Product Change Notification / GBNG-01CETU513

Notification Subject:

CCB 4427 Initial Notice: Qualification of NSEB as a new assembly site for selected Atmel ATXMEGA device family available in 64L (9x9x1mm) VQFN package.

Pre Change

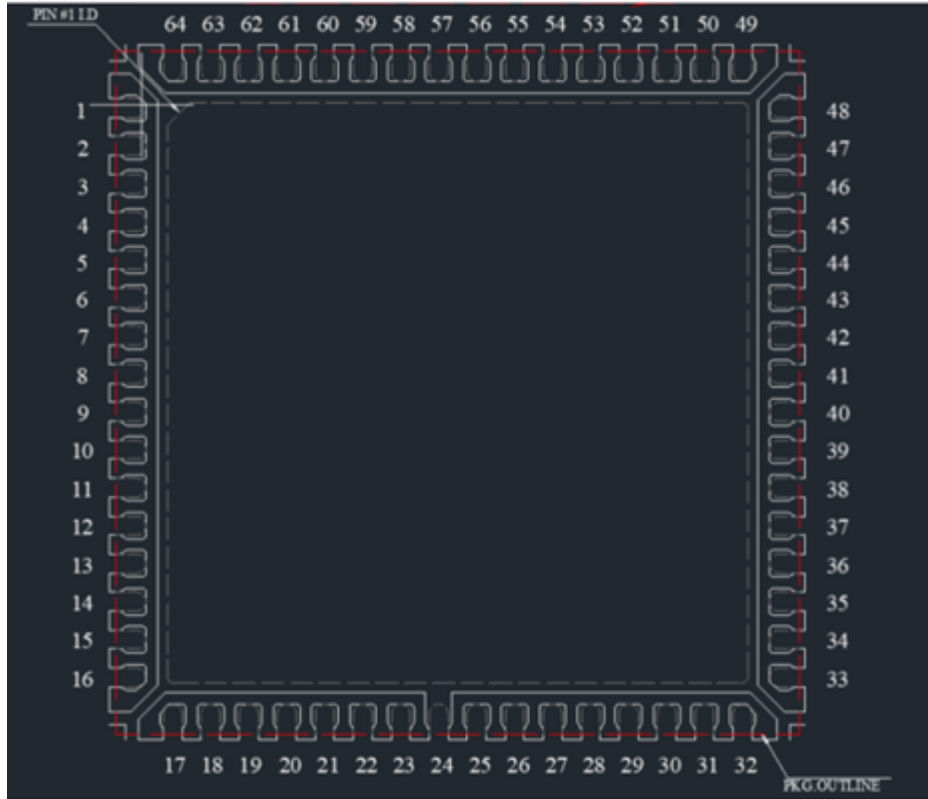
Lead-lock

No

Post Change

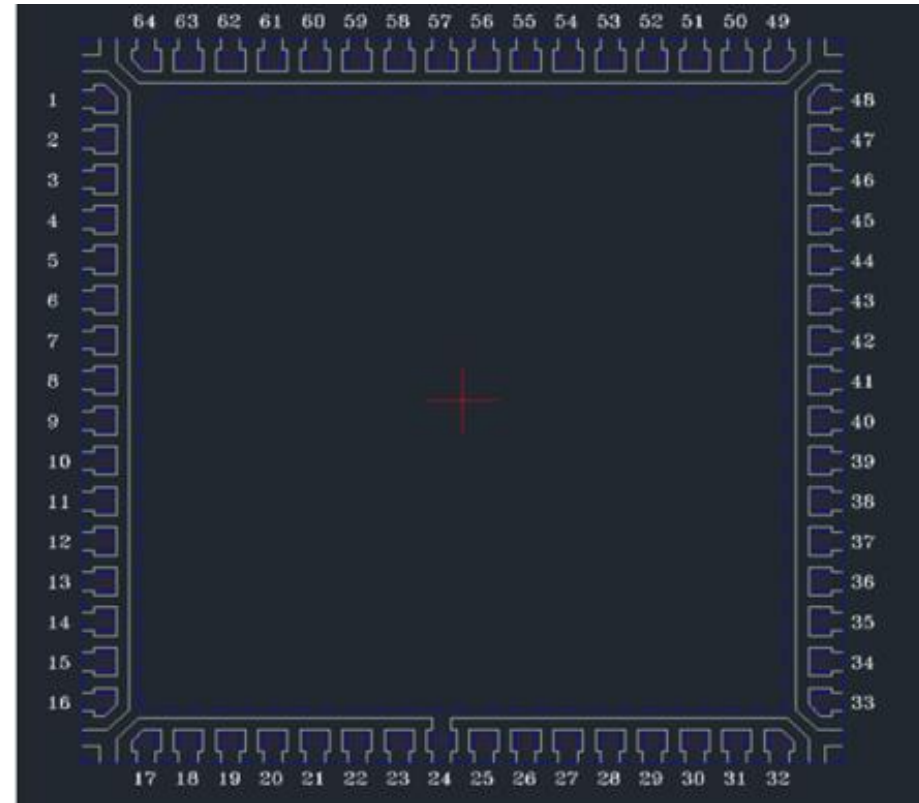
Lead-lock

Yes
